Subject: Bid No. 7800-W2, Coal Mine Brook Site Improvements / DPWP

# **ADDENDUM NO. 1**

**Project:** Coal Mine Brook Site Improvements

# V5665 Frame

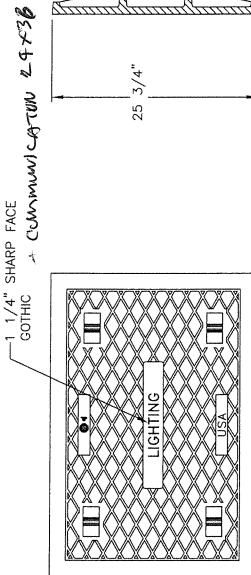
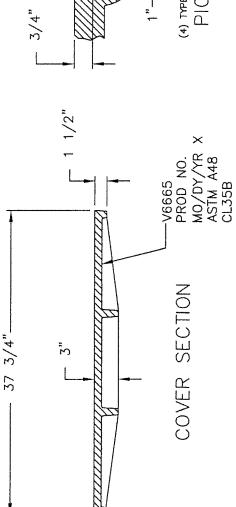
1. Detail of typical hand hole attached: - Precast concrete <u>flat wall</u> construction, H-20 design/test load or approved equal. Size for a typical electric hand hole is 12"x24" clear opening and 33" depth. Size for a typical communication hand hole is 24"x 36" clear opening and 36" depth. Include cast iron frame and cover (non- slip finish) with permanent Logo of "Electric" or "Communication". Final placement and routing of electrical and communication hand hole and conduits to be approved by Owner, no conduits or hand hole allowed within designated limit/footprint of outdoor exercise and playground areas.

Question2: Drawing E9 depicts a pre-cast HH with metal frame, and cover. The electric HH notes on

drawing E9 are conflicting as they specify a fiberglass product. Also the notes specify two different sizes, where are the different sizes to be used? These HH sizes, and spec are not

Answer: Refer to General Bid Clarifications item #1
